SHE-47-03.97

CYNTHIAN TOWNSHIP SHELBY COUNTY

REPLACEMENT OF THE BRIDGE DECK ON SR 47 OVER LORAMIE CREEK WITH MINIMAL ROADWAY WORK. THE REHABILITATION WILL INCLUDE SEMI-INTEGRAL ABUTMENT CONVERSION ALONG WITH REPLACEMENT OF THE BRIDGE BEARINGS, AND APPROACH SLABS. THE STEEL BEAMS WILL ALSO BE PAINTED.

PAVEMENT AND TRAFFIC PLAN & PROFILE
 SHE-47-0397

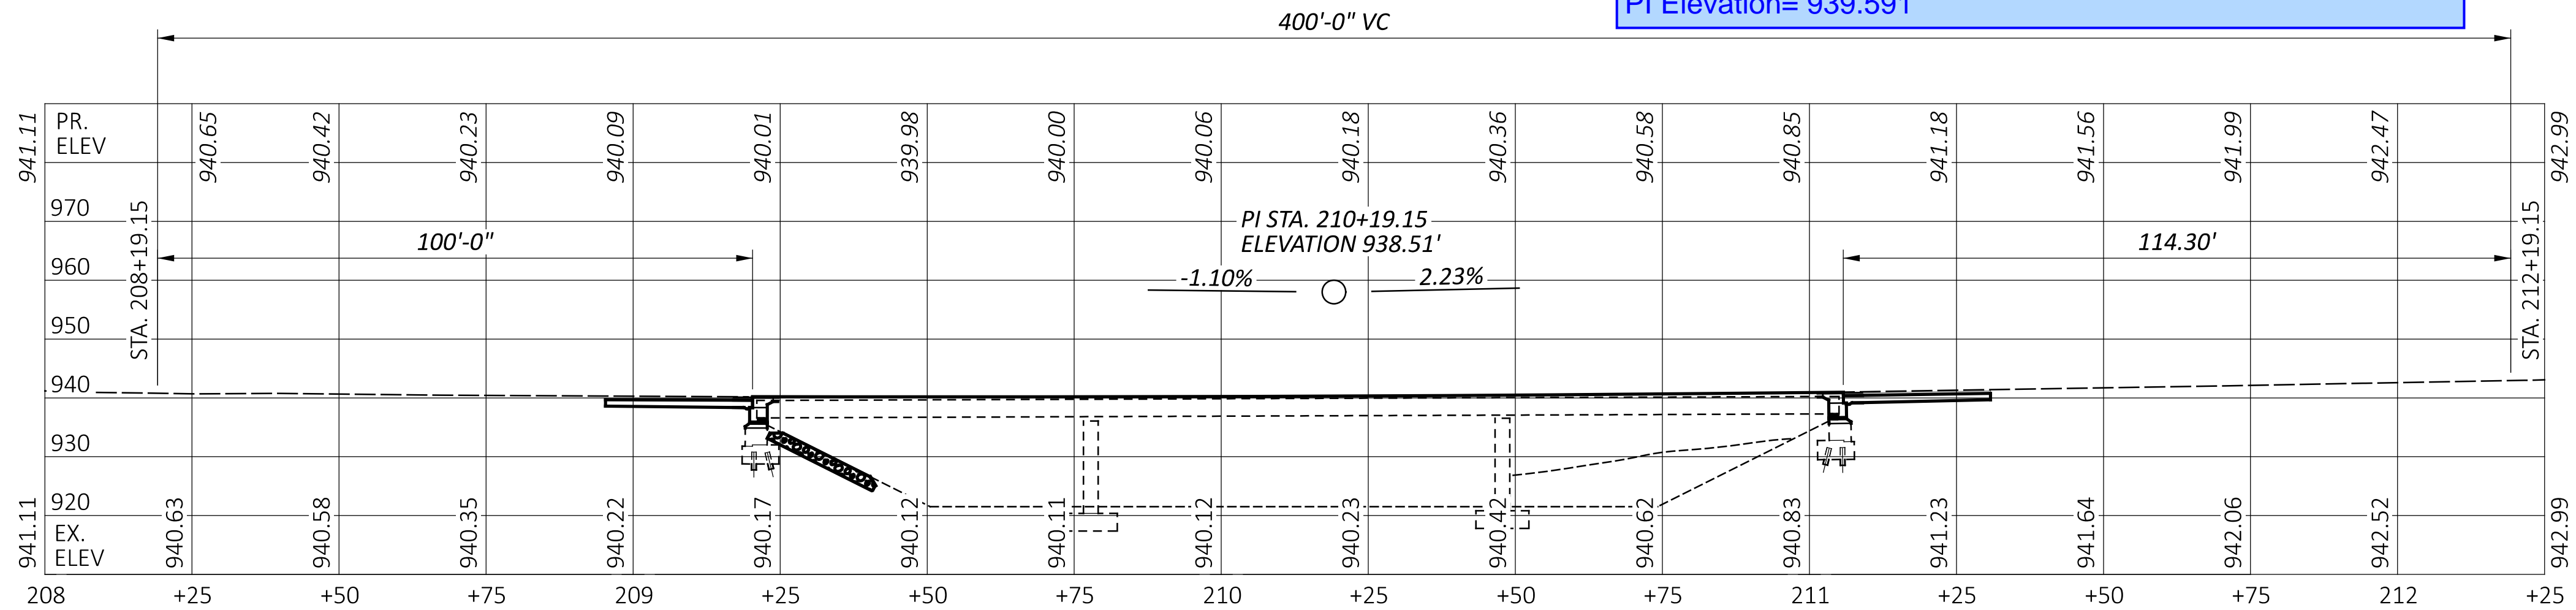
Vertical curve was modified to the following to accommodate 1.25" min. haunch and rework the wrong original screed tables. This issue came to light when the contractor submitted their top of beam survey tables. The plans had haunches set below the beams.

Length= 281.592'
 Start Station= 208+50.80
 G1= -0.72%
 G2= 1.26%
 PI station= 209+91.60
 PI Elevation= 939.591'

ABUTMENT DIAPHRAGM ELEVATION
 (ELEVATION VIEW SHOWN ALONG CL BEARING)
 REAR DIAPHRAGM SHOWN, FWD. DIAPHRAGM OPPOSITE HAND

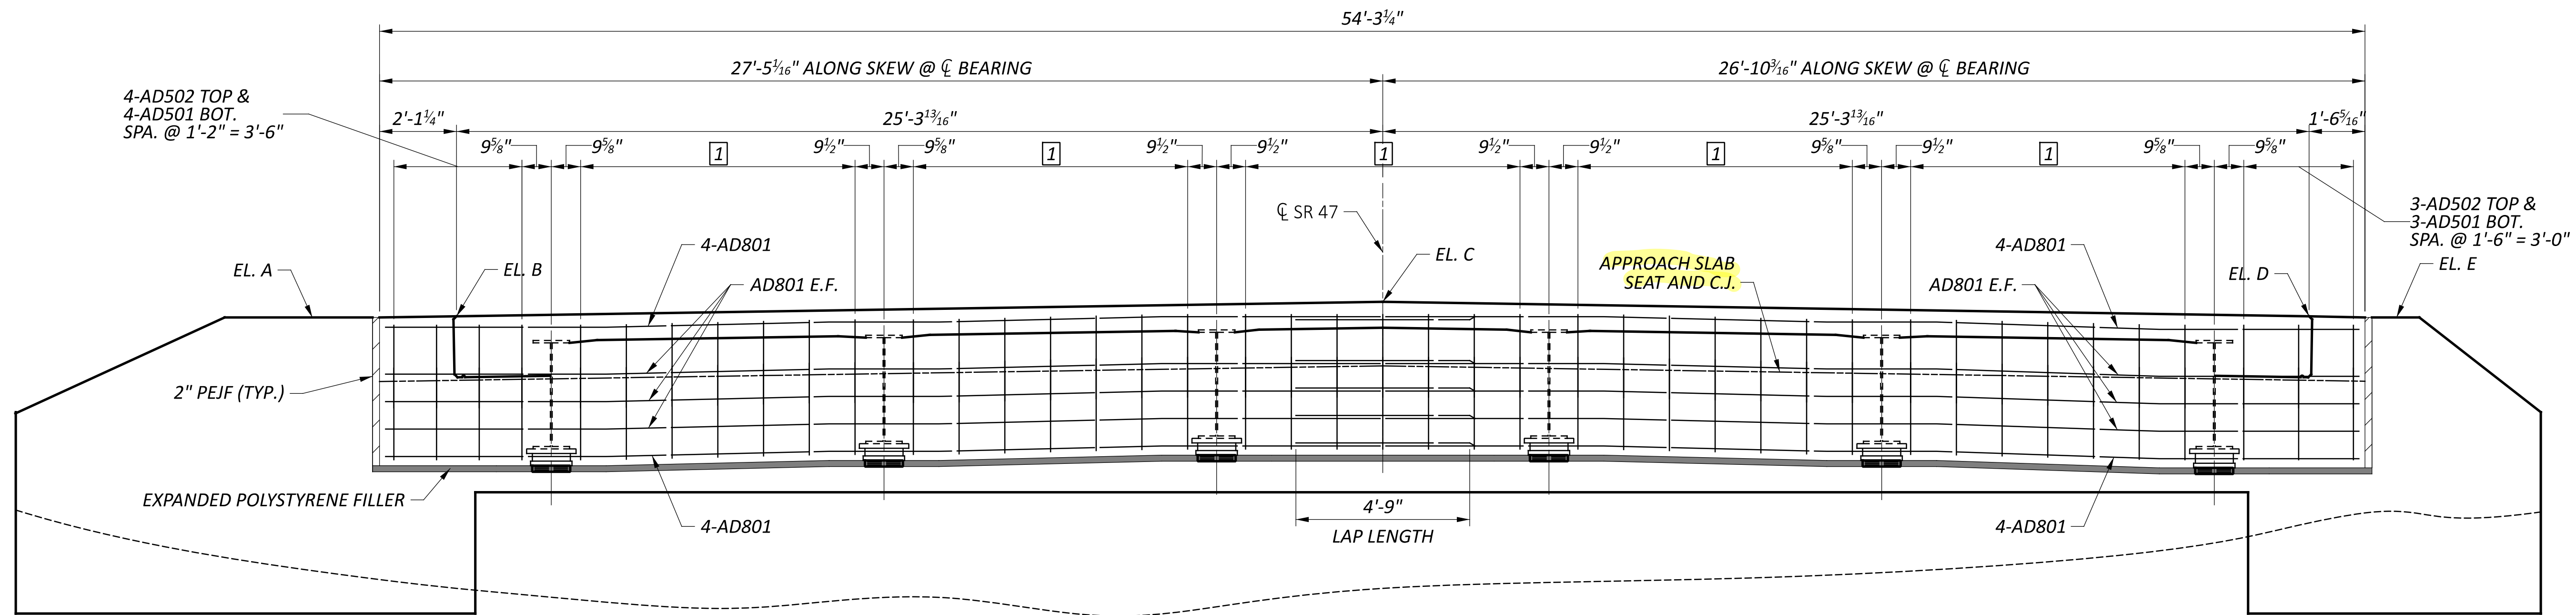
BDM 702.4.2. This is a steel structure with 30 degree skew.

PROPOSED TRANSVERSE SECTION

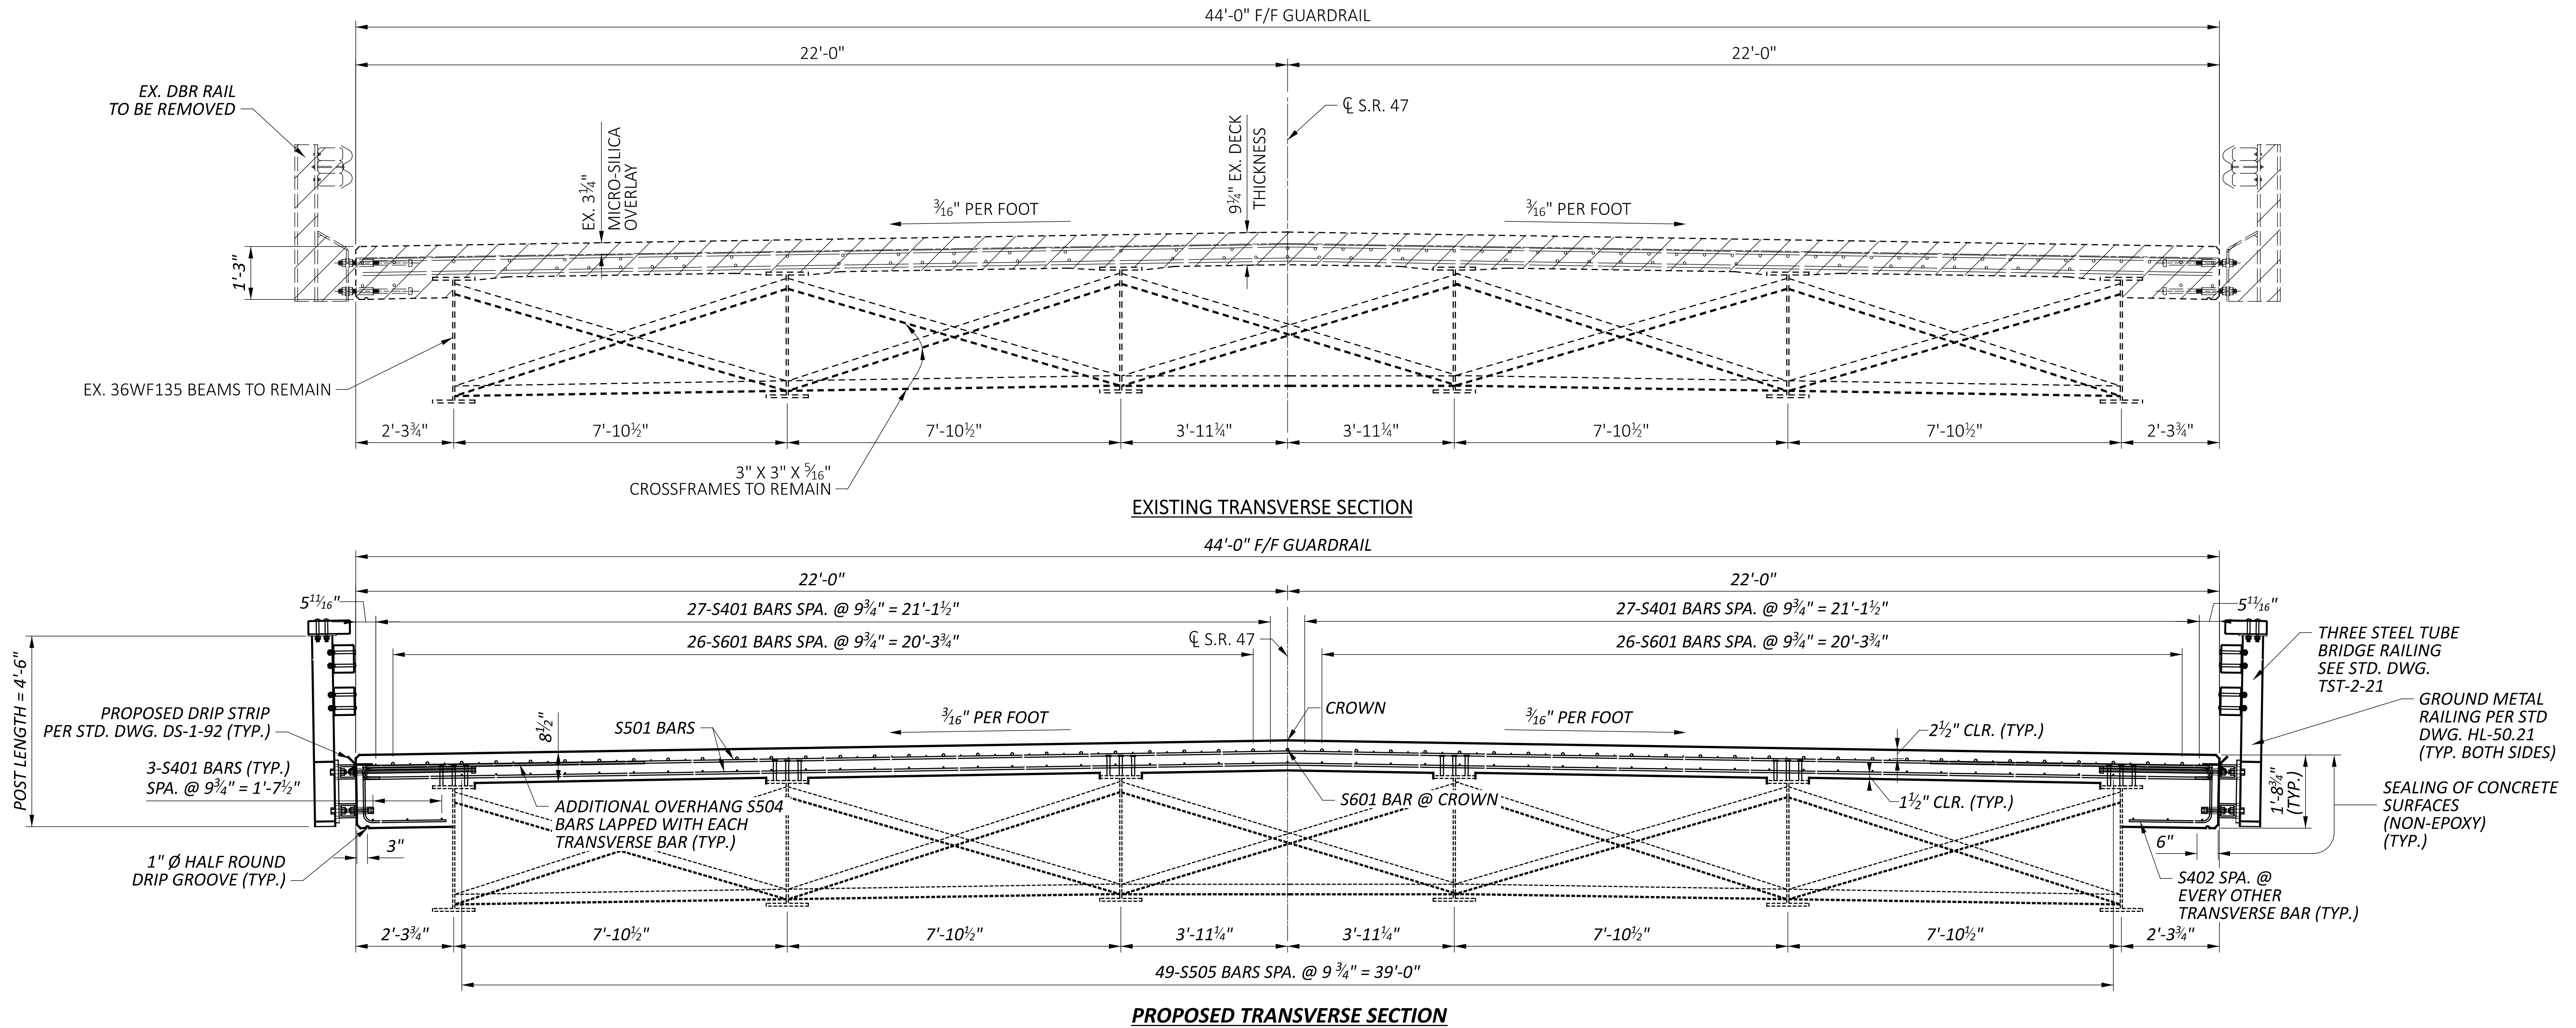
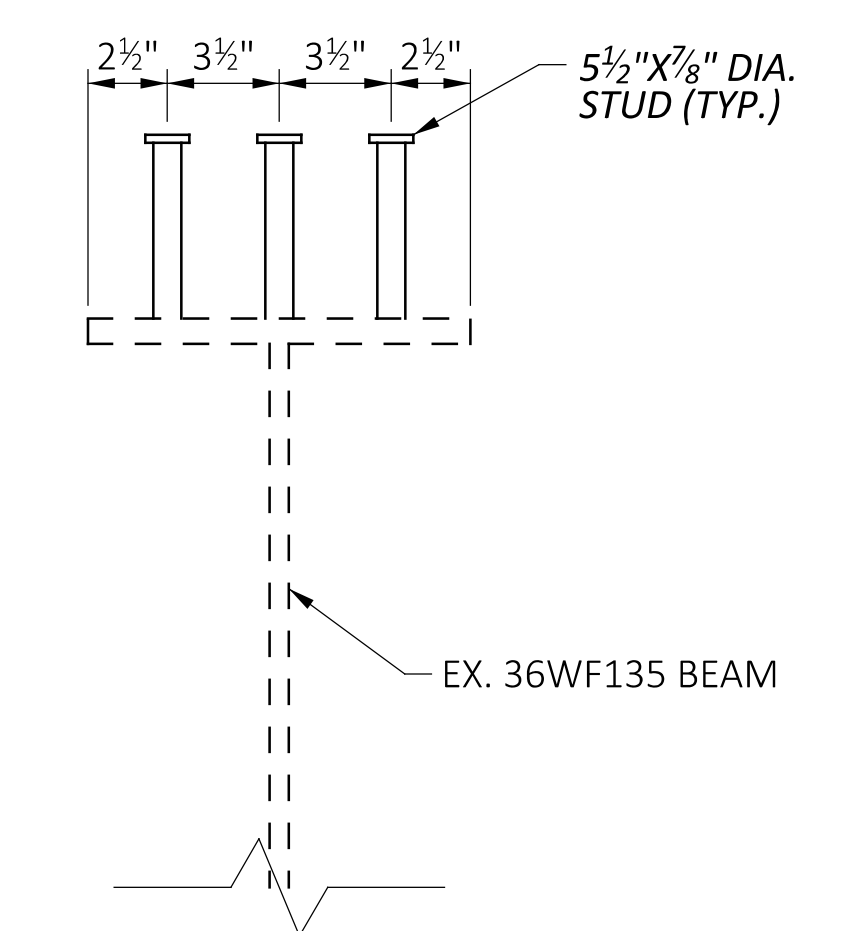
Haunches revised to be at least 1.25" to accommodate form work. Max haunch of 3 3/8"

BEAM ELEVATION (CONTINUED)

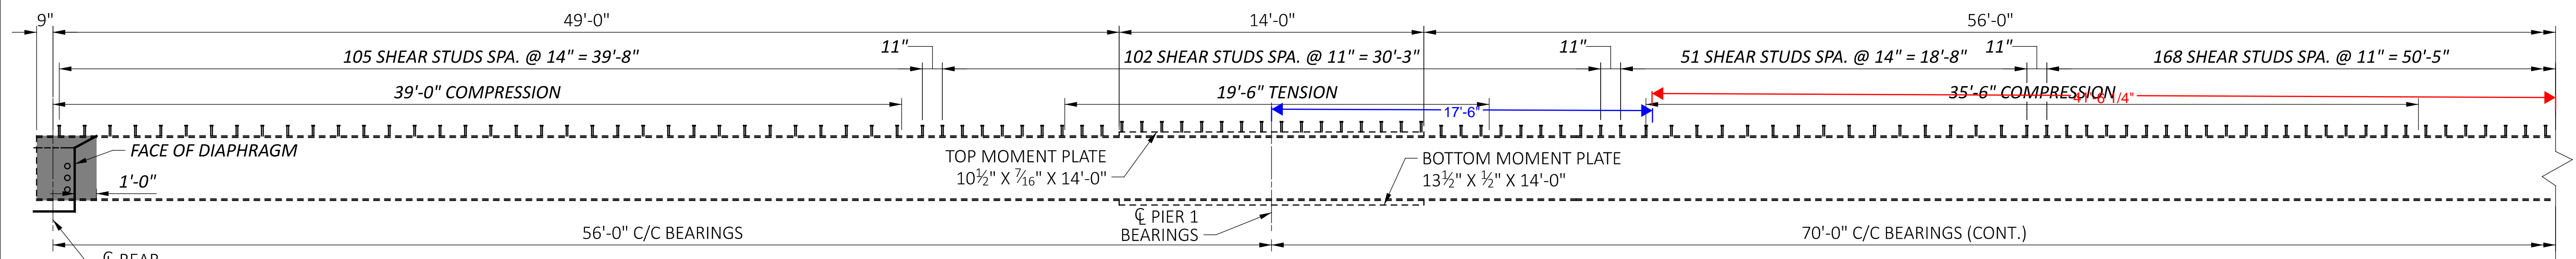
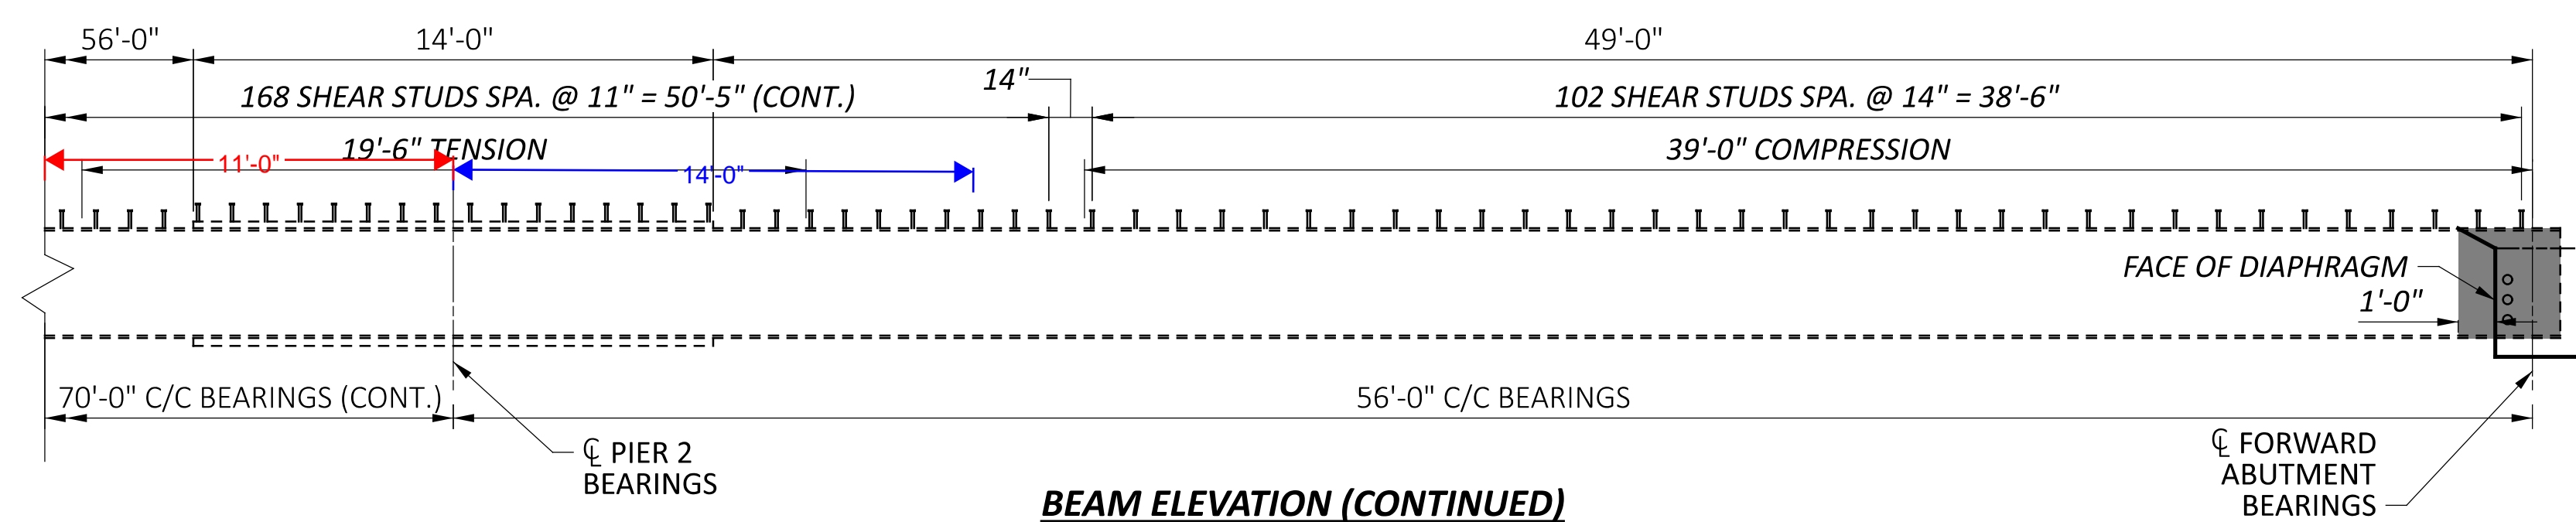
BEAM 1 Only
 53 x 3 = 159 6" studs if my
 eyes held out counting the
 studs.

All other studs 5"
 on BEAM 1 and
 rest of beams
